PLAN COMMISSION REPORT

Proposal: Amended Site Plan & Architectural Plans – Multi-tenant Industrial Building

Description: Review amended site and architectural plans for a proposed multi-tenant speculative industrial building.

RE: Site and Building Plan updates 10000 S. Ridgeview Drive (Tax Key 9269038000)

L1.5

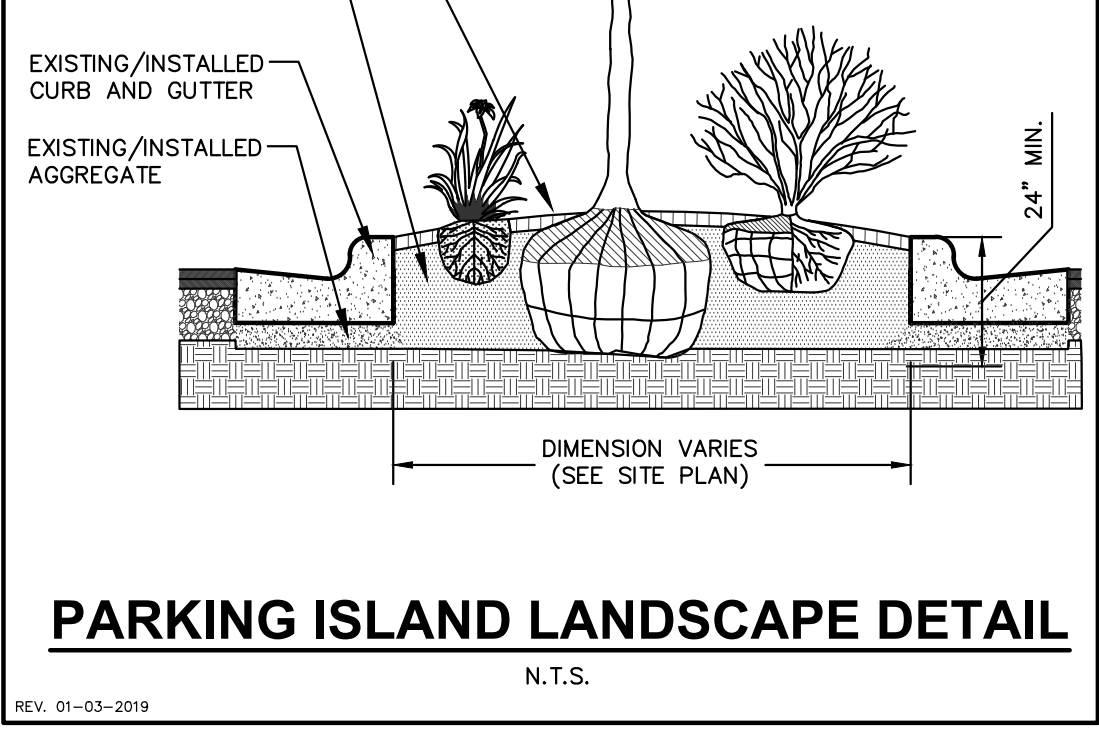
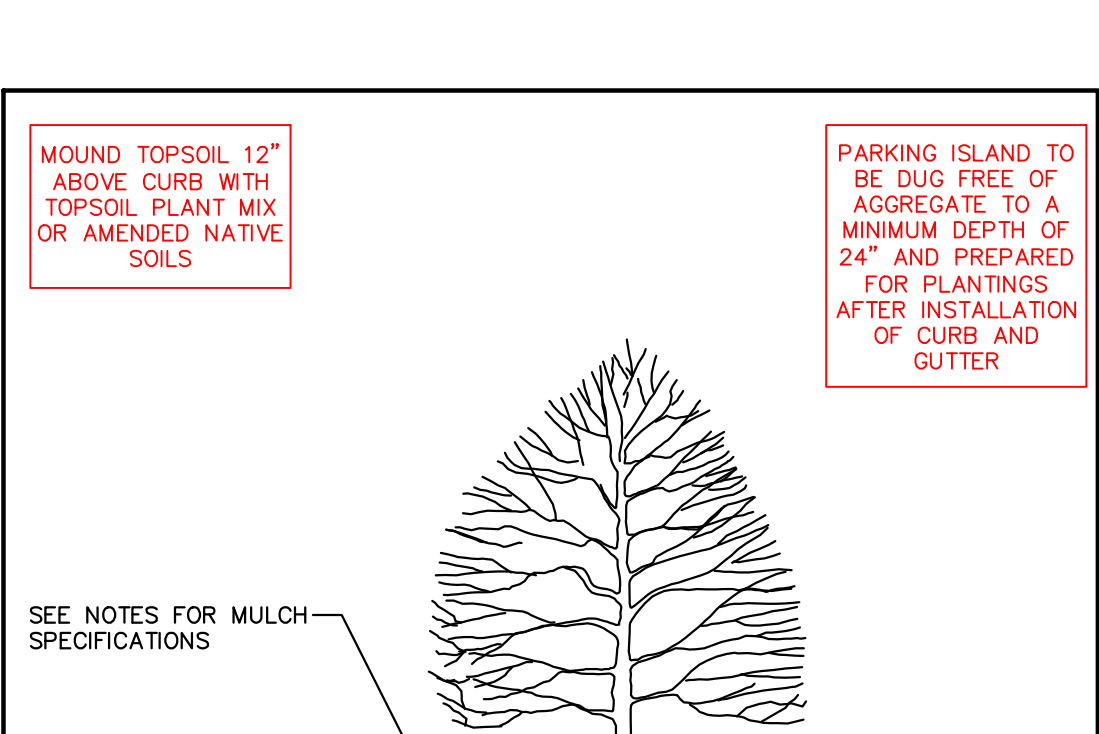
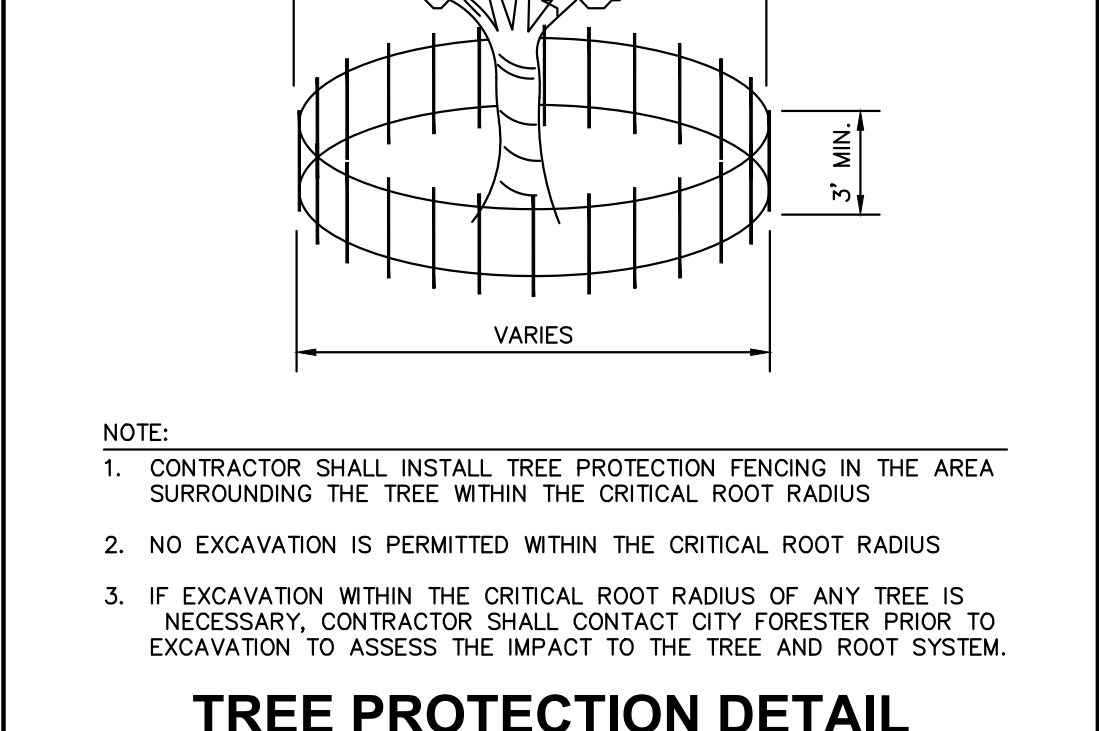
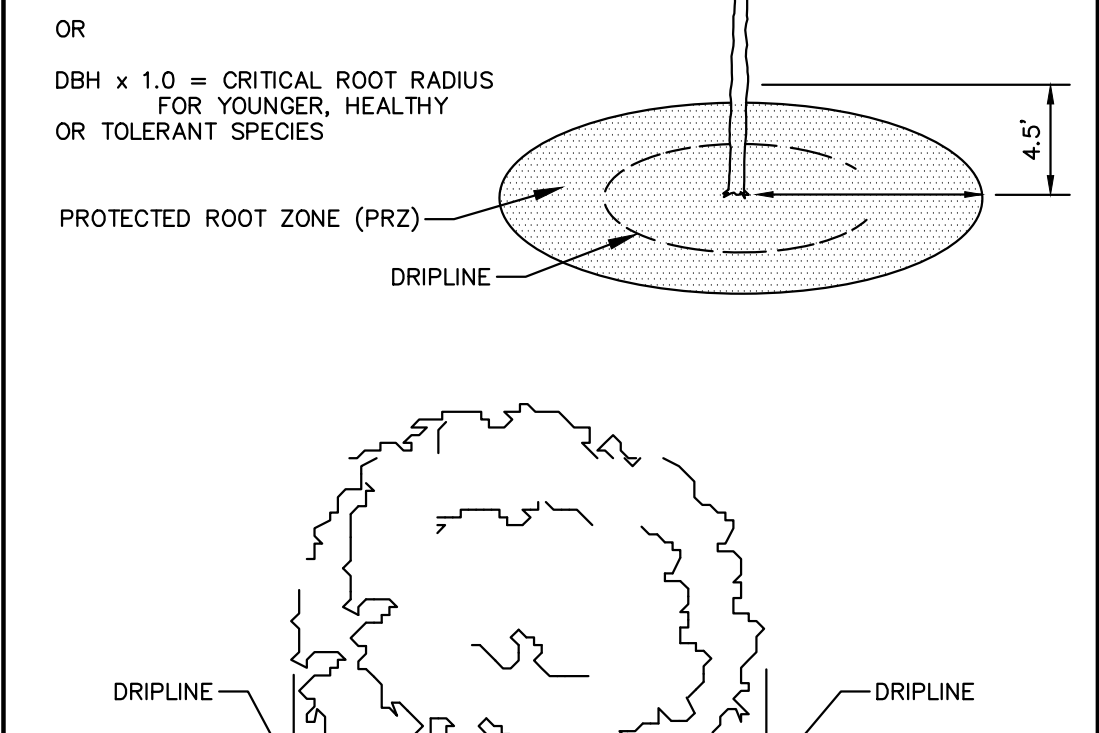
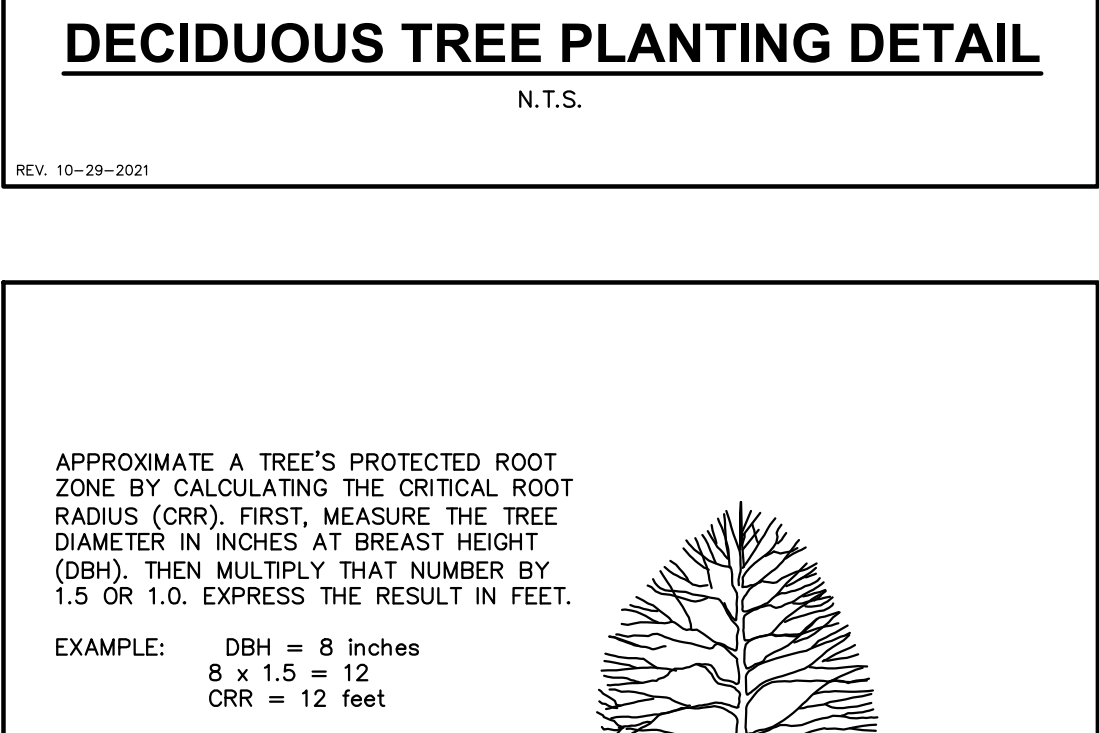
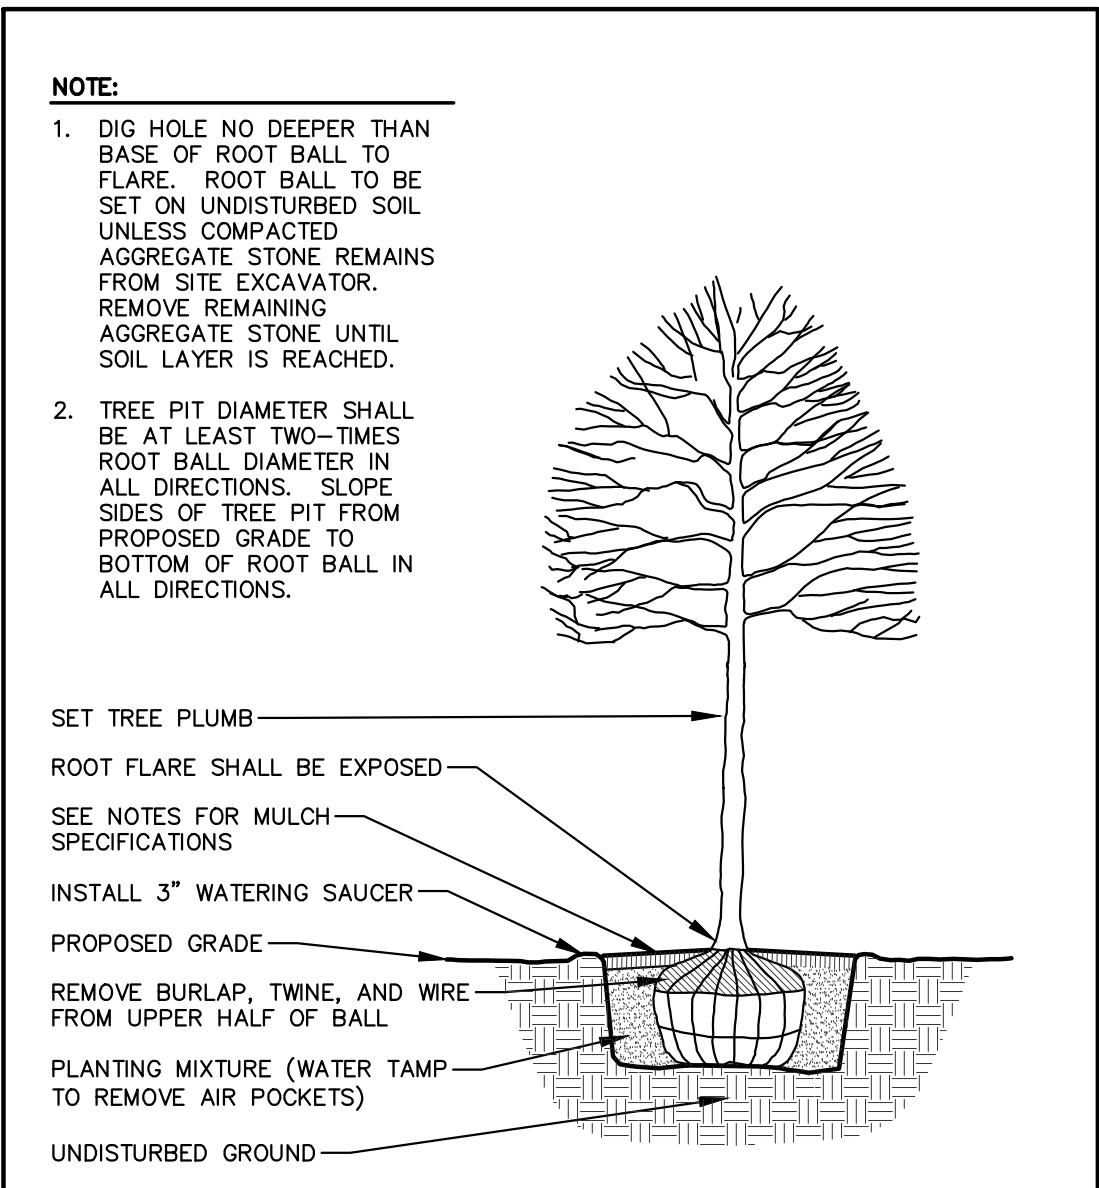
- a) Landscaping changes were made to increase the number of plantings on the already-robust site plan.
 - i. The changes are shown variously on Sheets L1.0 – L2.0 (additional parking lot island shrubs, perennials, and trees) but are best summarized by the Plant Schedule on Sheet L1.5 that shows 209 plantings have been added (+14 trees, +17 shrubs, and +178 perennials and grasses, comparing (8/15/25 version vs. 1/15/25 version).

- iv. All of the remaining interior parking landscape island locations shown in the northeast corner – and the 5 total number of other interior islands – match the previously-approved plans but we are requesting from the Plan Commission a Sec. 17.0505(e)(3) modification to the spacing standard (every 10 stalls) of landscaped islands upon supplemental design elements and improvements that are incorporated including: (1) the robust landscaping in the south areas of the site buffering the adjacent residences, (2) the 7 trees at the north property line transition area adjacent to an M-1 property, and (3) an overall +209 plantings that were added to the plan per the Plant Schedule on Sheet L1.5 (8/15/25 version vs. 1/15/25 version).
